# Buildings 1 & 2

JANUARY 12, 2022

COMPARISON:  
AUGUST 10, 2021 SPECIAL PERMIT PRESENTATION  
& JANUARY 5, 2022 SCHEMATIC PLANS PRESENTATION

WEST ELEVATION  
AUGUST 10, 2021

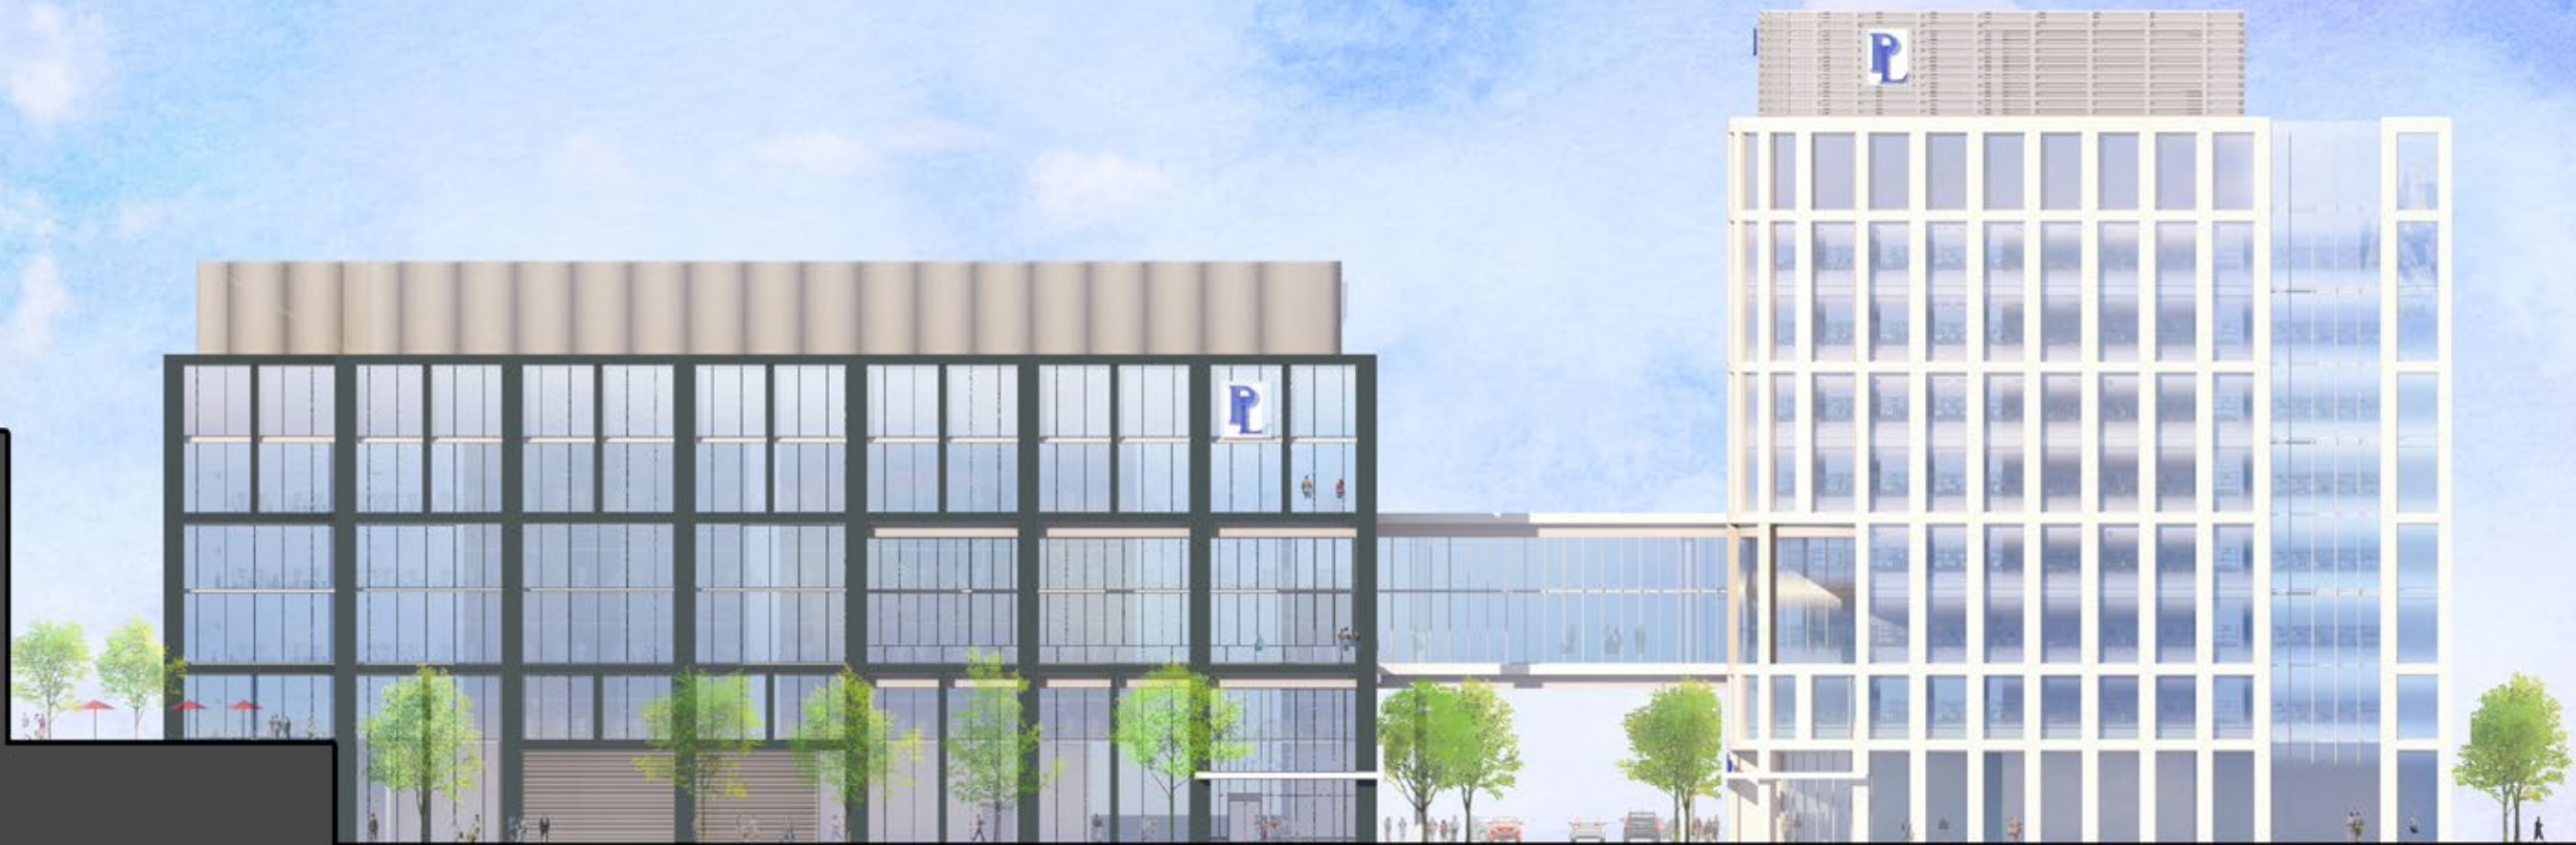
- change in cladding material at Building 1 to off-white terra cotta frame
- relocation and aggregation of exterior terraces to Level 3 (double-height)
- elimination of externally expressed cross bracing at Building 2
- introduction of serpentine perforated-metal screen at Building 2 upper penthouse
